**PLANNED UNIT DEVELOPMENT  
& SUBDIVISION STAFF REPORT****Date: June 5, 2008****DEVELOPMENT NAME**

Fort Conde Restoration

Fort Conde Restoration Subdivision

163 &amp; 165 St. Emanuel Street

# SITE PLAN

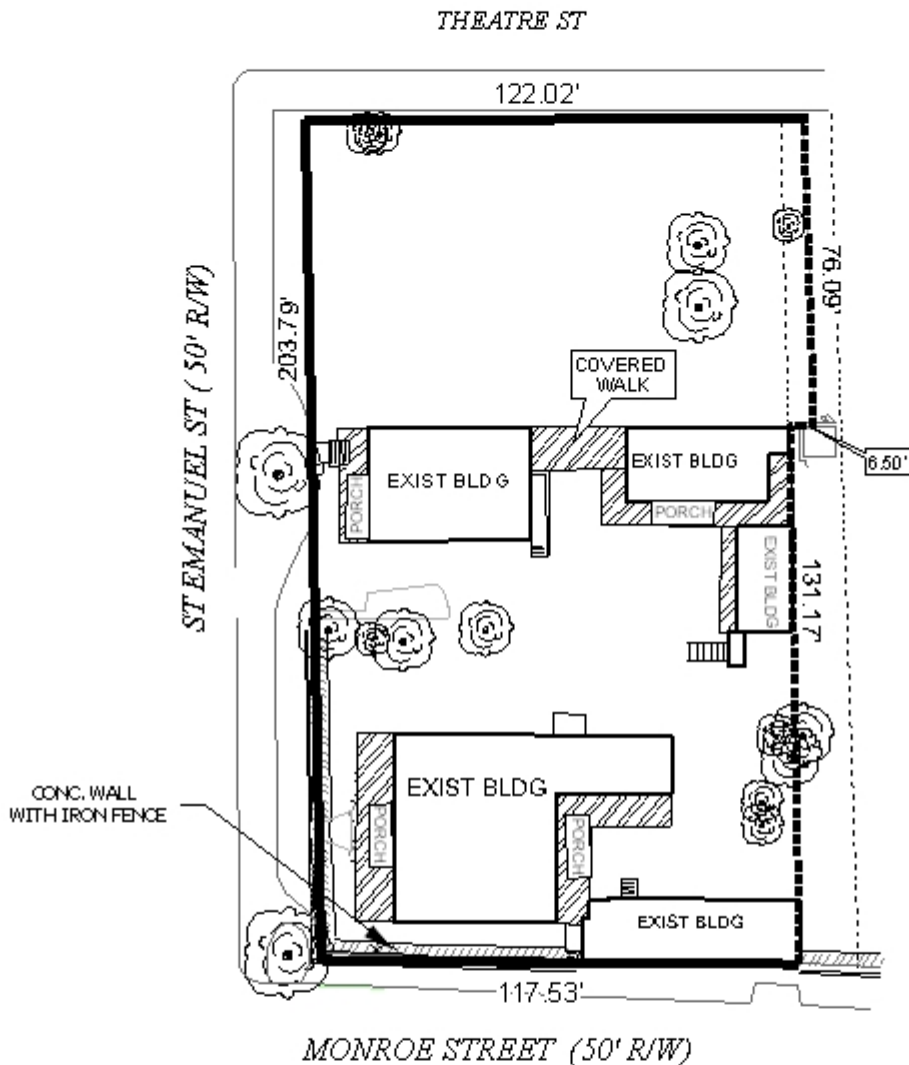
The PUD aspect of this application is for the shared cross-access between Lots 3 and 4, which are the Spear Barter and Hall Ford Houses, respectively. Given the historic nature of the Fort Conde Village and the existence of several large canopy trees, it is recommended that the applicant coordinate with Urban Forestry regarding the number and placement of required trees, if any.

There is no indication on the site plan as to the proposed location of any dumpster or other waste storage facility. The location of the storage area for the dumpster must be illustrated on the site plan and labeled, and the location and required screening must comply with Section 64-4.D.9. of the Zoning Ordinance, as well as with all other applicable regulations.

- 1) completion of the subdivision and PUD processes prior to the issuance of a C/O;
- 2) coordination with Urban Forestry regarding the number and placement of required trees, if any;
- 3) revision of the site plan to illustrate the location of a dumpster (and proper screening), or the placement of a note indicating that one will not be provided;
- 4) placement of a note on the site plan stating that Planned Unit Development review is site plan specific; therefore any future changes to the site plan (including the addition of parking) will require an amendment to the PUD; and
- 5) provision of a revised PUD site plan to the Planning Section of Urban Development prior to signing the final subdivision plat.

# SUBDIVISION DETAIL

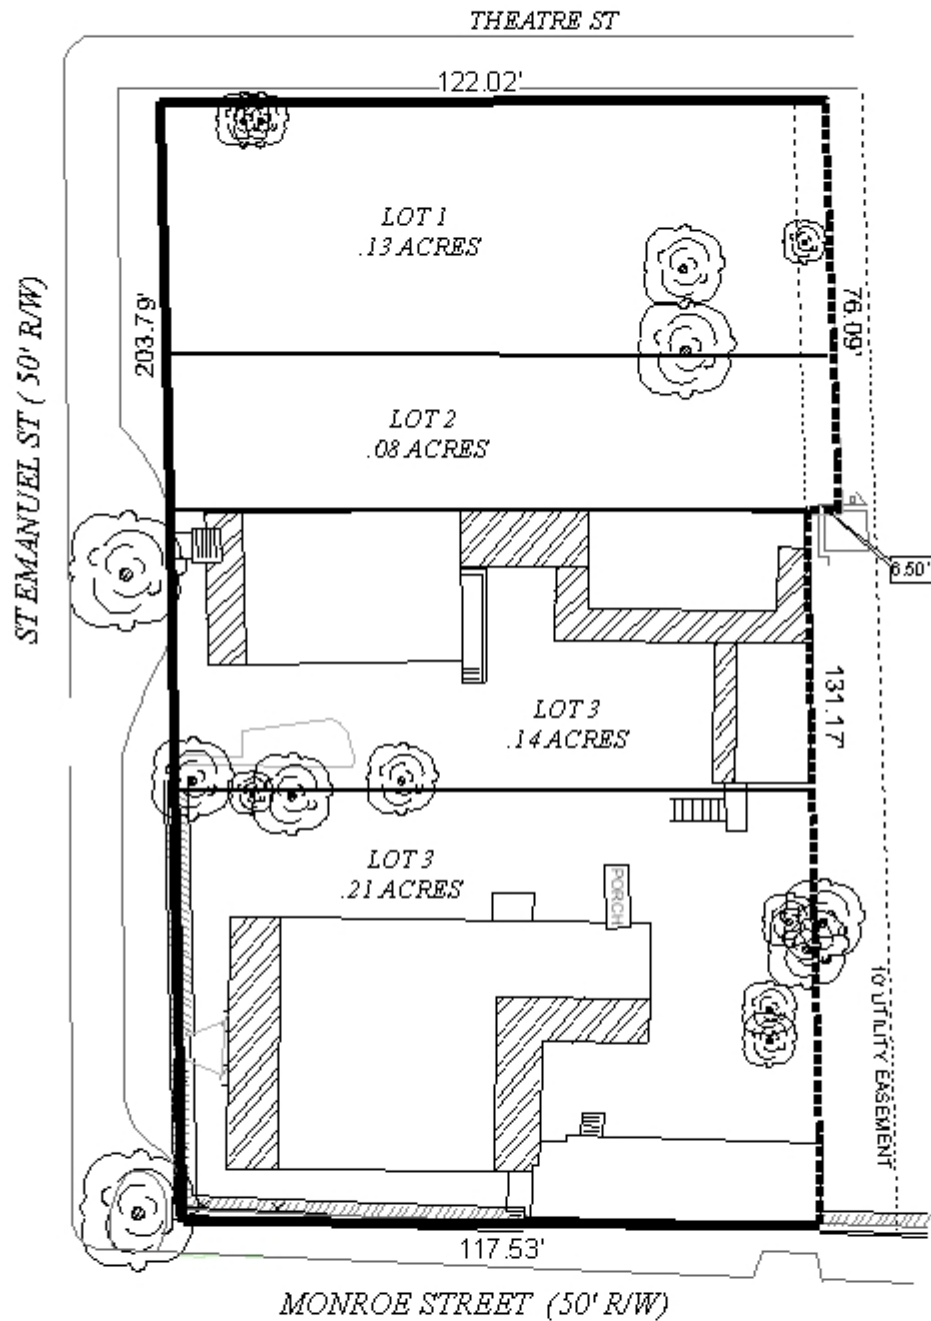
It should be noted that Lots 1 and 2 are substandard in size and width, and they exceed the maximum width to depth ratio. However, given the age of the parcels and their location in Historic Fort Conde Village (typical substandard lots), a waiver of Sections V.D.2. and 3. of the Subdivision Regulations may be appropriate.

There is no depiction of the minimum building setback line on the plat, which should be addressed prior to signing the final plat. A minimum 5' front setback is required in a Historic Business District.

As proposed, the site does not reflect an adequate radius at the intersection of St. Emanuel Street and Monroe Street. The applicant should revise the plat to comply with Section V.B.16. of the Subdivision Regulations.

- 3) depiction of the 5' minimum building setback line prior to signing the final plat;
- 4) provision of an adequate radius, in compliance with Section V.B.16. of the Subdivision Regulations, at the intersection of St. Emanuel Street and Monroe Street;
